This Service Bulletin describes how to replace the CLS sensor, and if necessary, the sensor cable. If the new sensor is identical to the sensor being replaced, the cable is not needed. If an old-style sensor is being replaced with a newer-style sensor, the cable must be replaced and routed as described here.

## Replacing the CLS

**Figure 2: Remove Parts Shown**

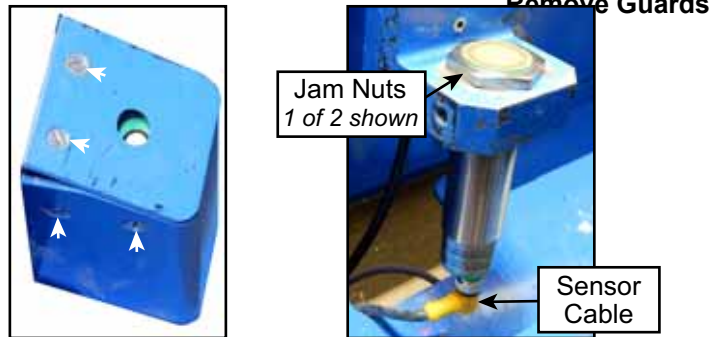
1. Remove old CLS sensor as shown in Figure 2.

**Figure 4: Prepare the New CLS**

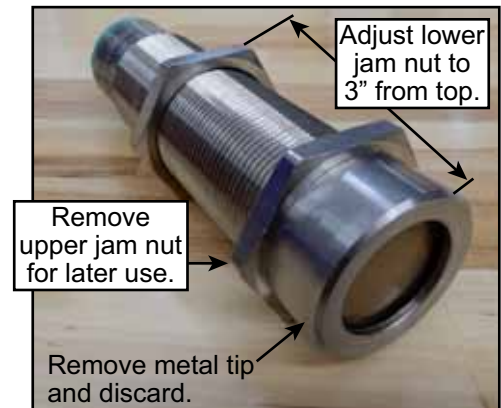
- a) Prepare the new CLS sensor as shown in Figure 4.
- b) Insert the sensor from the bottom of the bracket and place the second jam nut on from the top.
- c) Tighten both jam nuts so the sensor top surface is flush with the jam nut's top surface.
- d) Tighten the lower jam nut.

**Figure 5: Adjust Nuts**

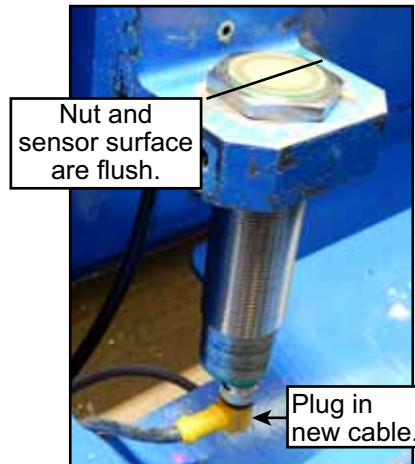
1. Ensure the nuts are adjusted correctly so the top of the top jam nut and the top surface of the sensor are flush as shown in Figure 5.
2. Plug the existing sensor cable into the bottom of the CLS sensor.
3. Attach the sensor guards and front door.
4. Restore power.
5. Run a few test cuts to ensure the CLS is working.

**Figure 6: Cable Routing Overview and Guard to Remove**

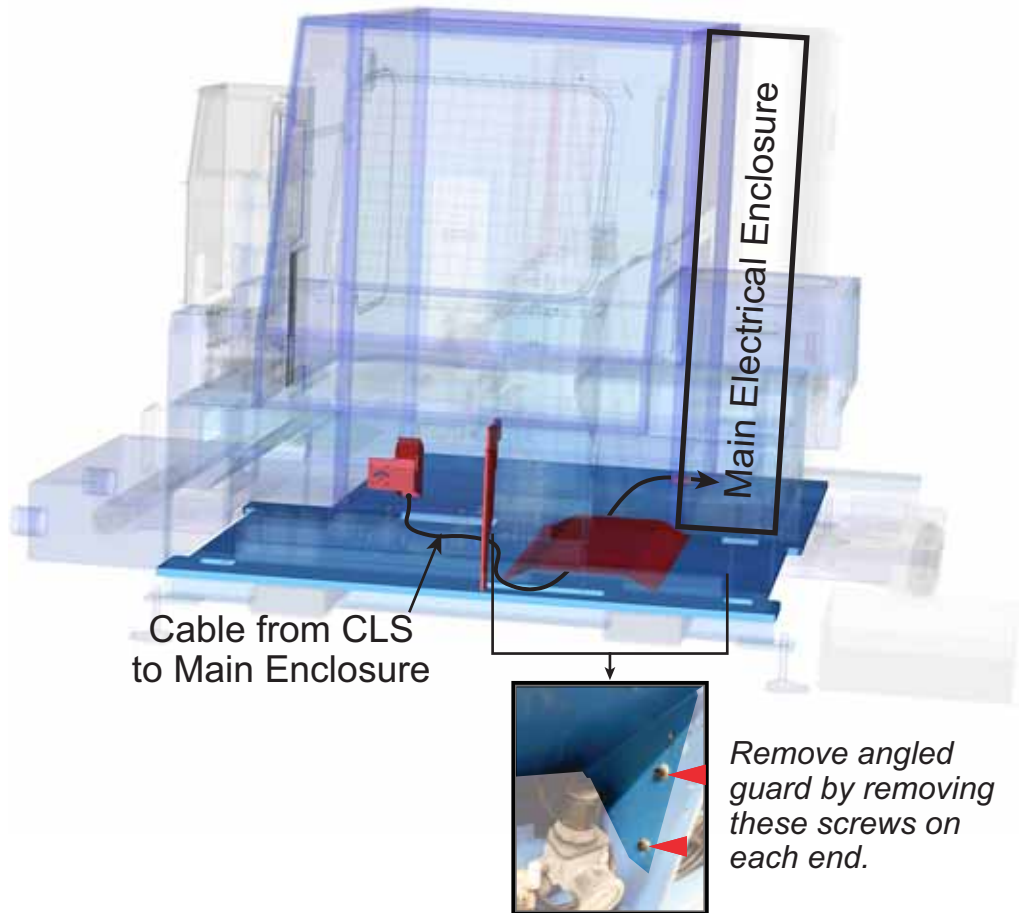
1. Remove the angled guard behind the pneumatic regulators shown in Figure 6.

**Figure 11: Wire Termination Points Inside the Bottom Main Electrical Enclosure**

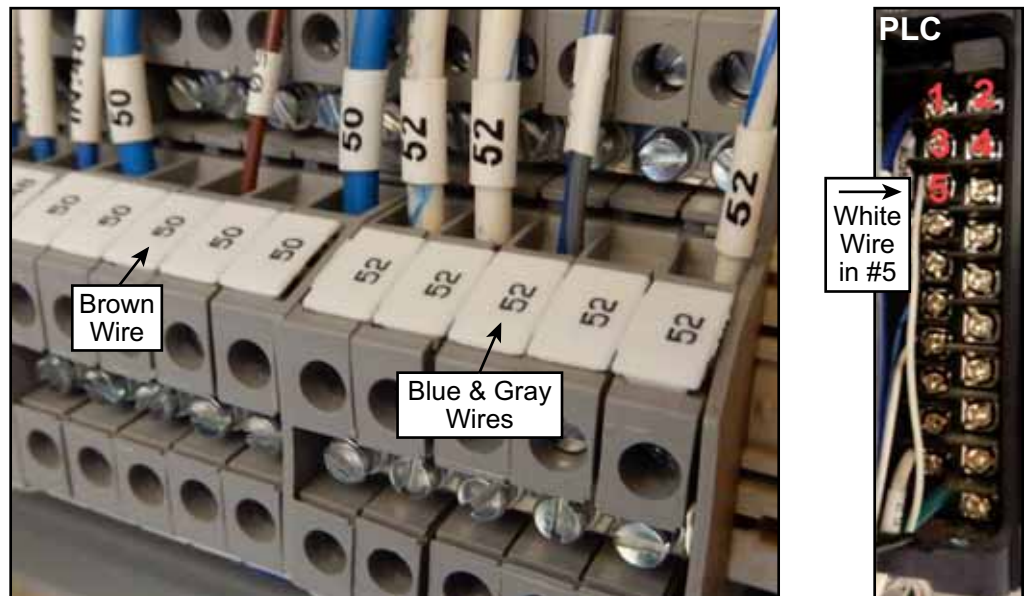
8. Remove the OLD cable from its terminals, and terminate each wire in the NEW cable according to Figure 11.

**Figure 12: Adjust Nuts**

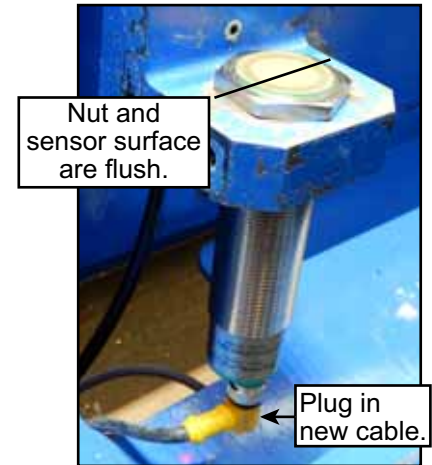
- a) Once the new cable is routed, follow its complete route and add new cable ties wherever necessary to keep your enclosures and chambers neat and safe.
- b) Ensure the fitting in the stroke/elevation chamber (shown in Figure 9) has been tightened in place.
- c) Ensure the nuts are adjusted correctly so the top of the top jam nut and the top surface of the sensor are flush as shown in Figure 12.
- d) From the front of the saw, finish routing the connector-end of the new cable and plug the cable into the bottom of the CLS sensor.
